Linthorpe Road, Middlesbrough
Proposed Restoration Works

Combined Stage 1 and Stage 2 Road Safety Audit

6. LOCATION PLANS OF ITEMS RAISED BY THIS AUDIT

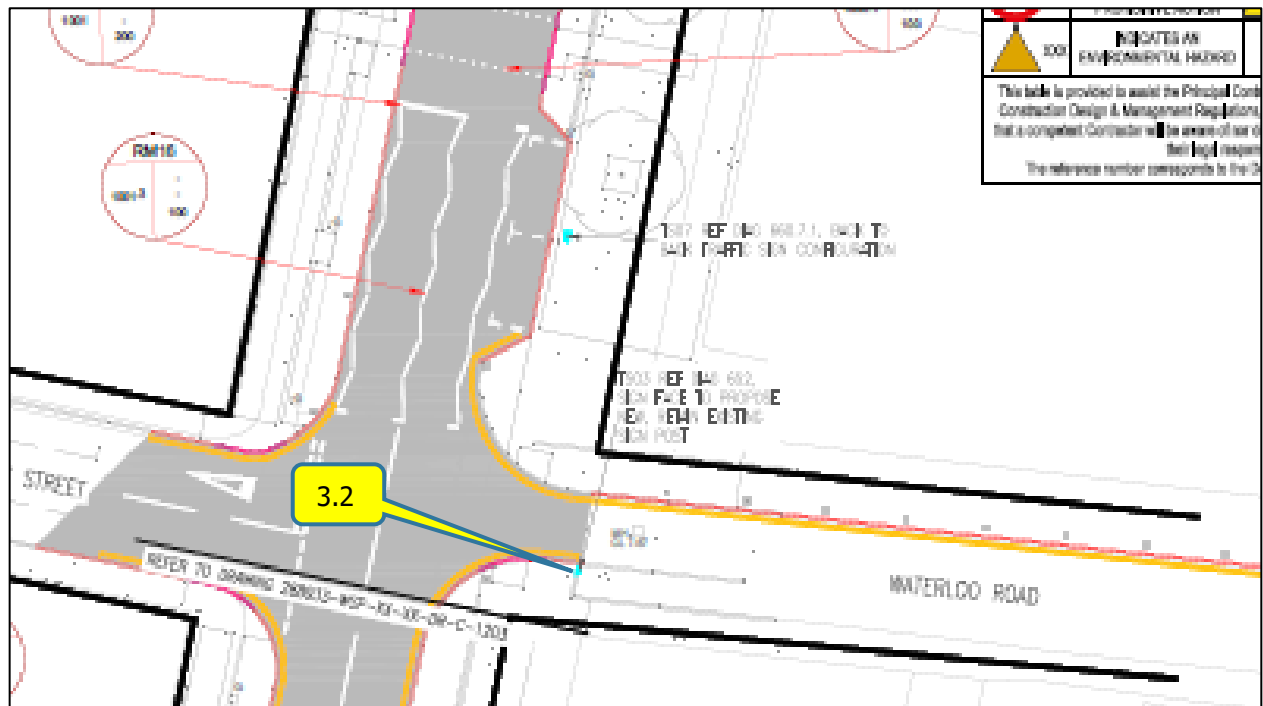
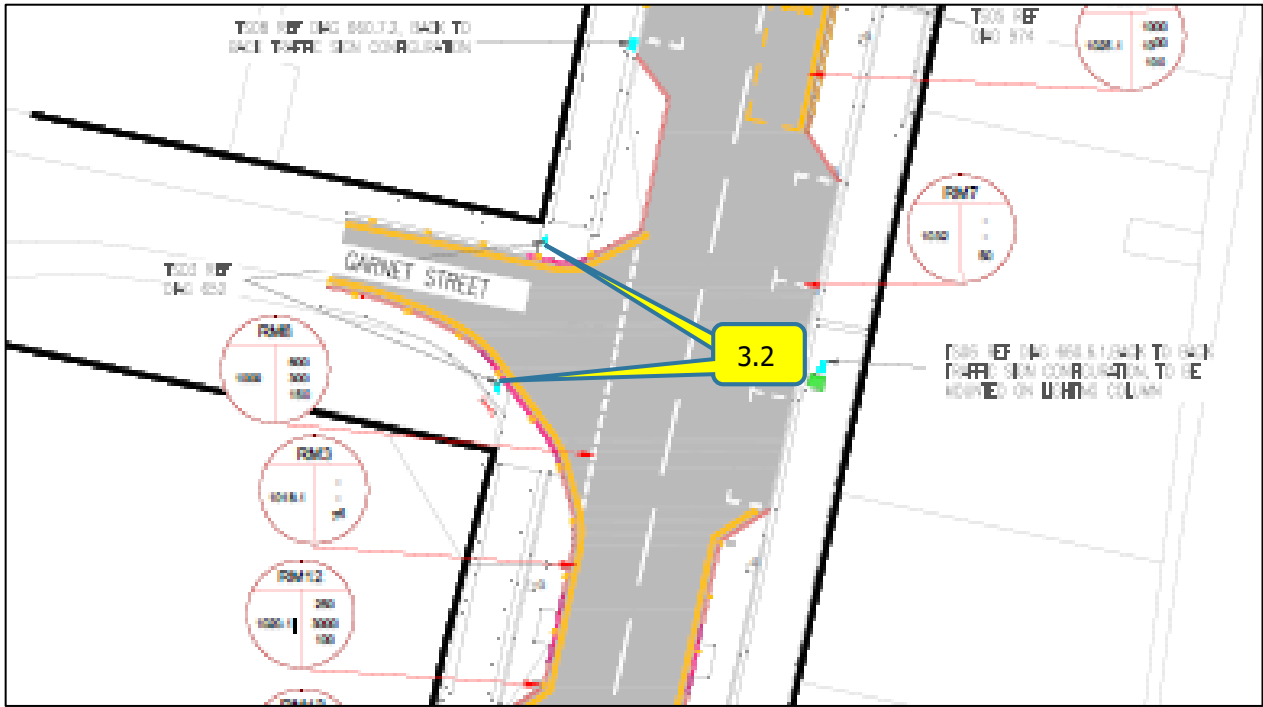
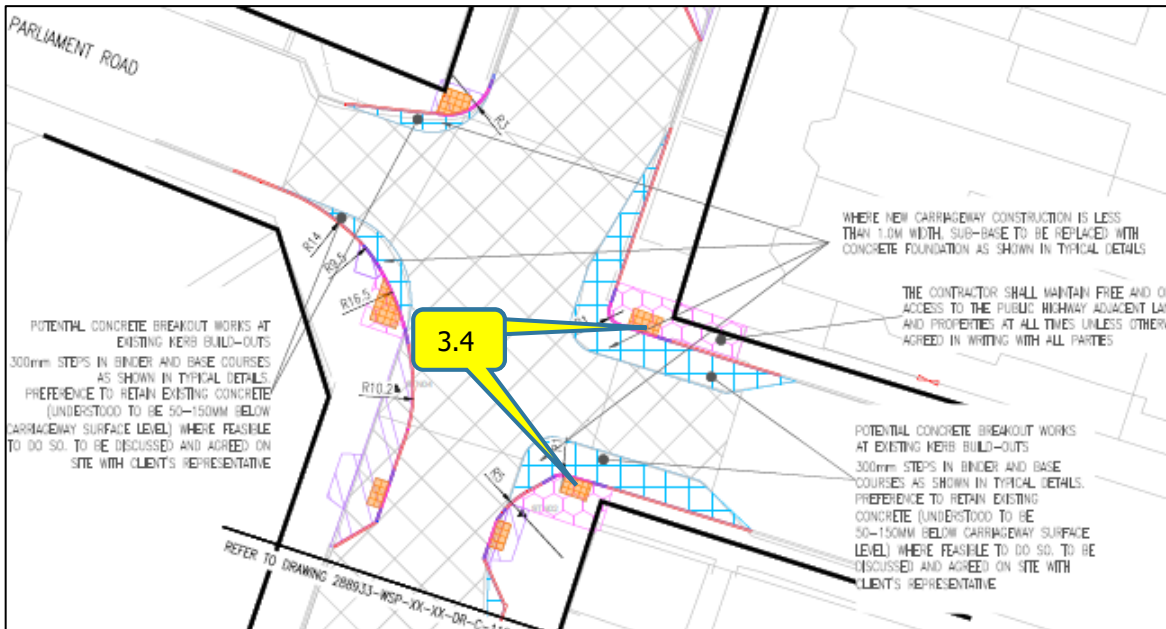
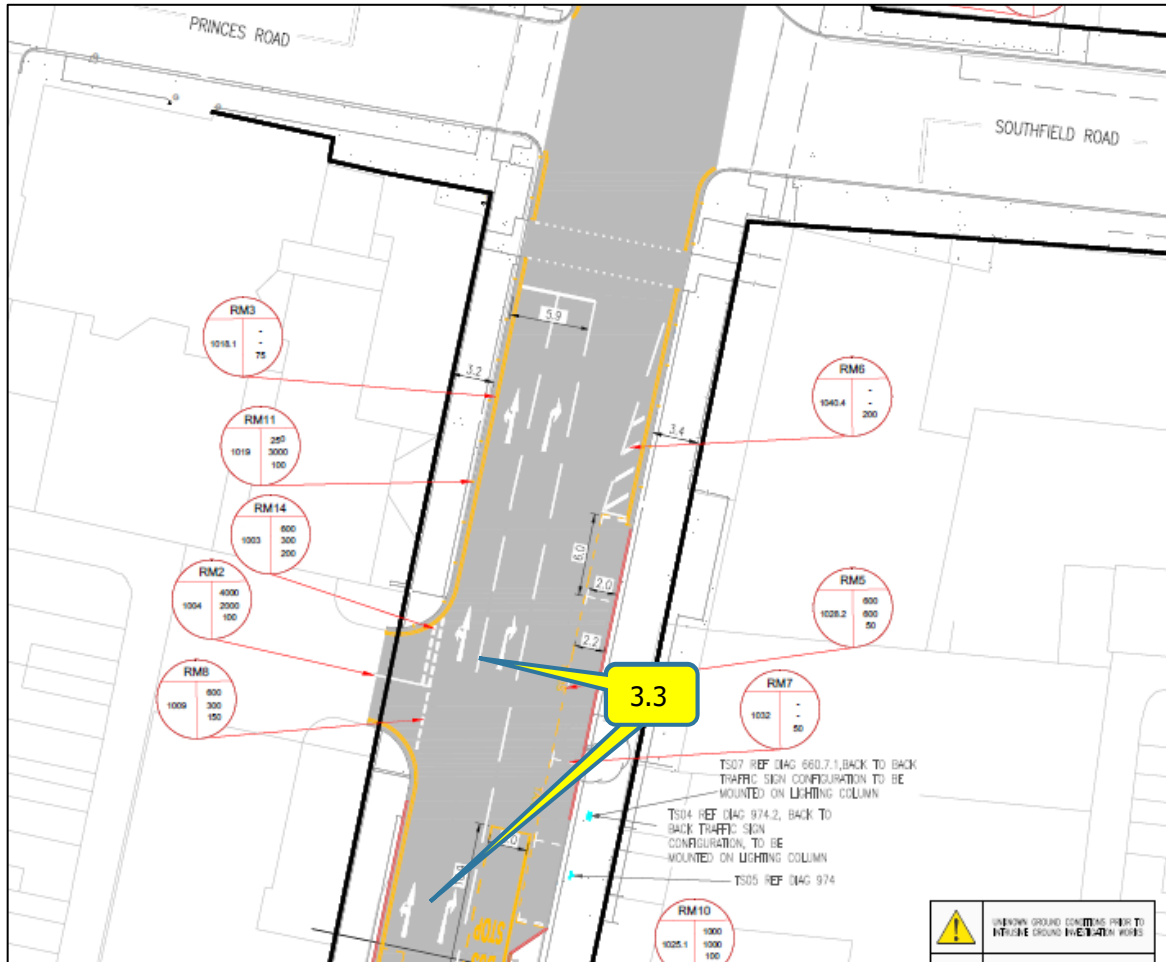
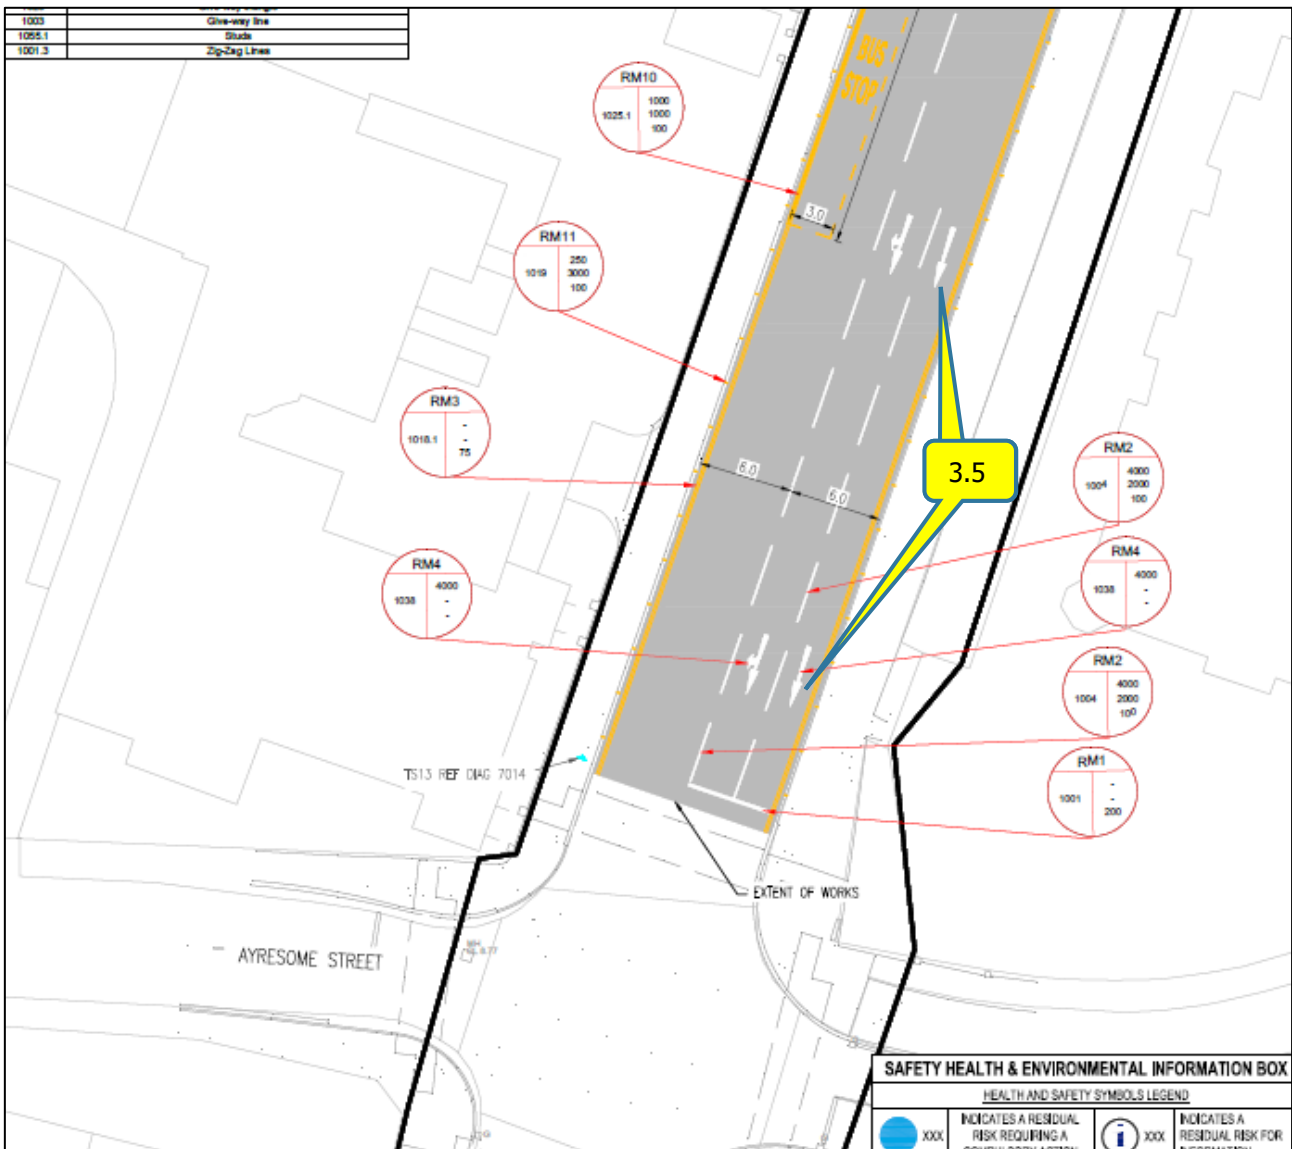
3.1, 3.6, 3.7, 3.8 & 3.9 – throughout the scheme
